R E S O L U T I O N

WHEREAS, the application for approval of the aforesaid Preliminary Subdivision Plat, also known as Preliminary Plat 4-00010, was presented to the Prince George's County Planning Board of The Maryland-National Capital Park and Planning Commission by the staff of the Commission on July 6, 2000, for its review and action in accordance with Article 28, Section 7-116, Annotated Code of Maryland and the Regulations for the Subdivision of Land, Subtitle 24, Prince George's County Code; and

NOW, THEREFORE, BE IT RESOLVED, that pursuant to the provisions of Subtitle 24, Prince George's County Code, the Prince George's County Planning Board APPROVED Preliminary Plat of Subdivision 4-00010 with the following conditions:

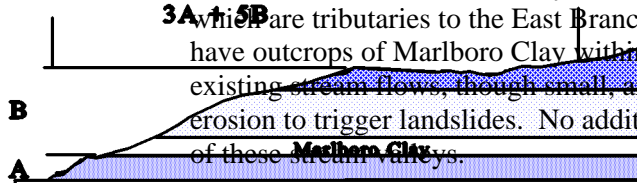
slope (Figure 1.) . A site-specific geotechnical report may show that development can be placed closer to the toe-of-slope by better defining the High Risk Area, especially if mitigation measures are taken as part of the development.

The illustration indicating the potential Marlboro Clay outcrop pattern shows a High Risk Area computed by this model. Note that this area is based upon existing conditions. Grading can change the location of the risk area. Grading which removes material at the toe-of-slope or on a Marlboro Clay outcrop can aggravate the situation and cause the risk area to enlarge. Grading which adds material within the risk area above a Marlboro Clay outcrop can enlarge the risk area. Grading which removes material from above the Marlboro Clay can decrease the risk area.
